MILITARY SPECIFICATION

MICROPHONE ELEMENTS, CARBON AND EARPHONE ELEMENTS, MAGNETIC (FOR TELEPHONE AND RADIO USE)

DIAGRAM, SCHEMATIC, ARTIFICIAL LINE
R=44 Ohms 1/2W ± 10%
C = 0.-54 MFD ± 10% 200 DCWV

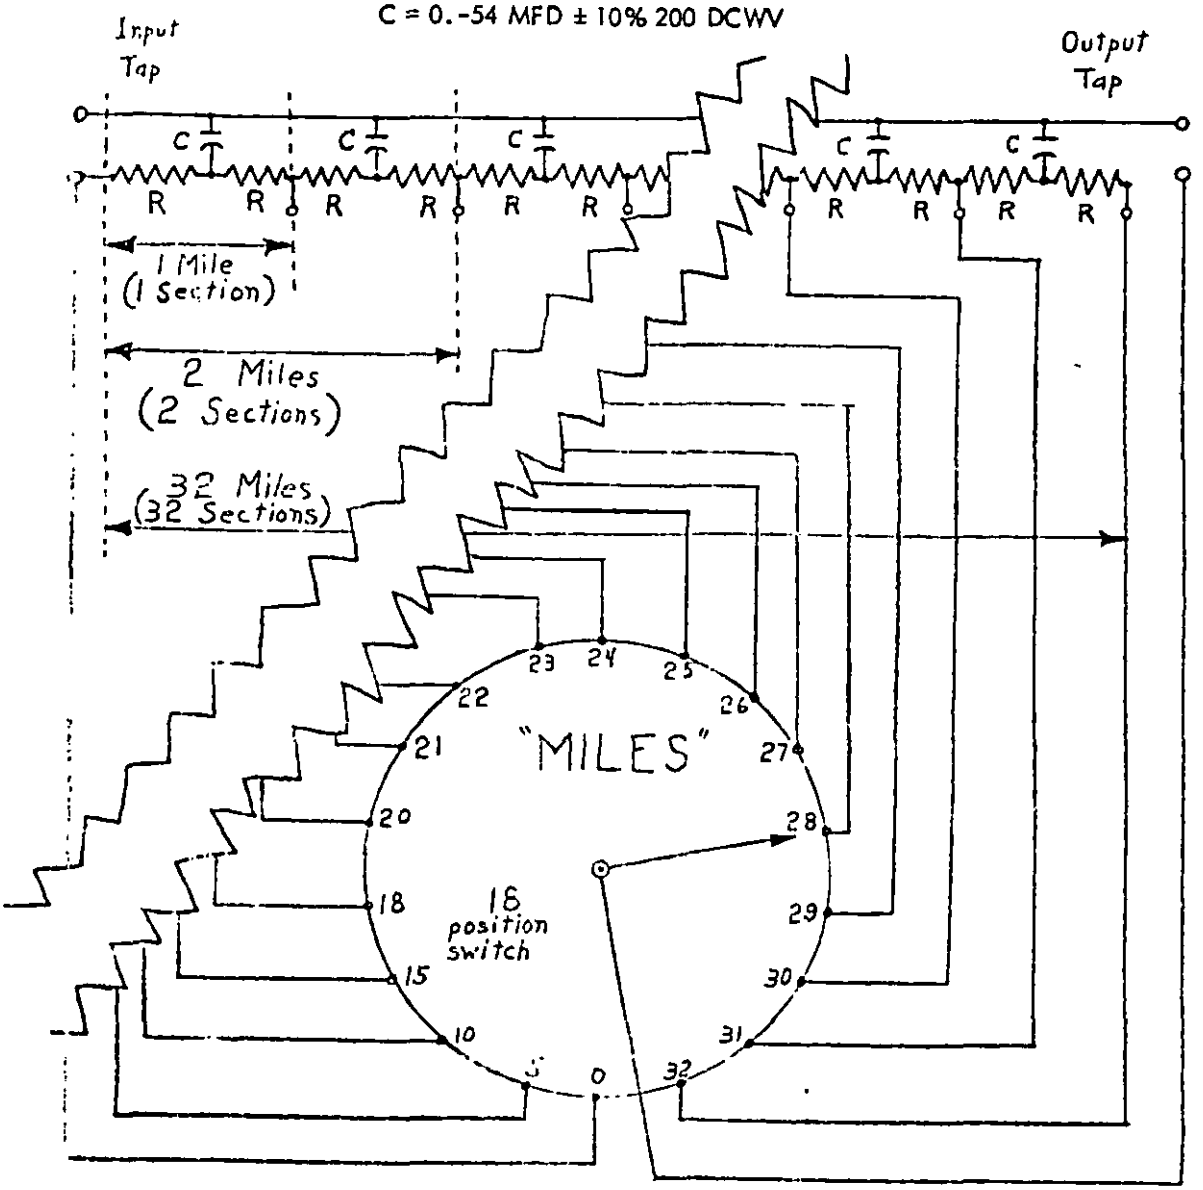
5. Paragraph 4.6 *Talk test.* In first sentence change "in an equipment telephone circuit" to read "in accordance with the telephone circuit as shown on figure 3".
